**ZONING AND PLATTING COMMISSISON  
HILL COUNTRY ROADWAY SITE PLAN  
AND VARIANCE REQUESTS**

**CASE NUMBER:** SPC-2009-0349C      **HEARING DATE:** November 2, 2010

**PROJECT NAME:** The Trails at 620

**FROM:** Shandrian Jarvis, Transportation Planner  
**DATE:** October 26, 2010  
**SUBJECT:** SPC-2009-0349C Trails at 620 -Traffic Analysis Update

FIGURE 1  
CONCEPTUAL  
SITE PLAN

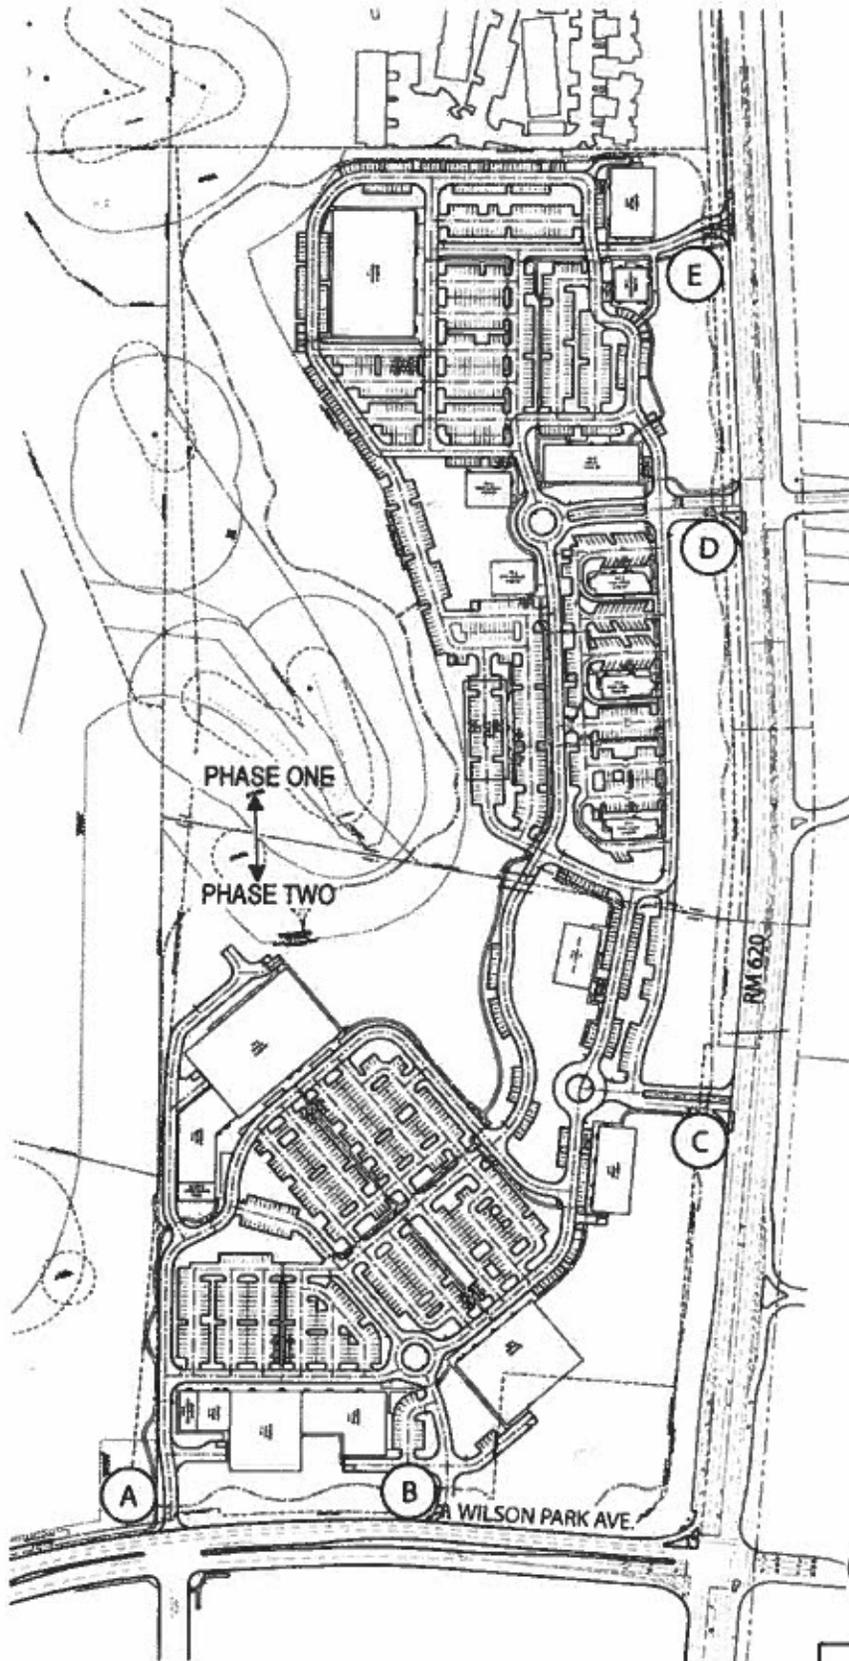
2. If permitted, the proposed third driveway (Driveway E, Attachment 1) should be constructed as a right in/right out only driveway with a deceleration lane as part of the site development phase of the project. Prior to the release of the site development permit, the applicant should post fiscal for the estimated cost to construct the deceleration lane. Deceleration lanes serving only one project (e.g. left or right turn lanes at a private driveway) are funded 100 percent by the applicant. The applicant should submit a schematic drawing with dimensions and a construction cost estimate signed and sealed by an engineer to verify the amount required for posting. It is recommended that these improvements be implemented by the applicant to assure safer access and circulation into the site.

Analysis results indicate that provision of a third site driveway (Driveway E) designed as a right-in/right-out only driveway with a deceleration lane - Scenario 2 - will benefit traffic operations along RM 620 in addition to internal traffic flow. This will allow traffic from the north on RM 620 to circumvent the traffic signal at the RM 620/Concordia University Drive intersection, which reduces the traffic demand that the signal must handle. In fact, delay at the intersection of RM 620 and Concordia University Drive is reduced by 40% with the addition of the third driveway.

Wilson Parke Avenue. It is recommended that this driveway (Driveway E) be constructed as a right-in/right-out only driveway with a deceleration lane; therefore, there will be no additional left-turn maneuvers created by this driveway. It's proximity to the proposed movie theater will be particularly helpful in moving traffic into the site in an efficient manner. The ability for southbound traffic on RM 620 to make an unrestricted right turn into the site immediately prior to the traffic signal creates a unique opportunity to relieve congestion on RM 620 through the placement of the third driveway.
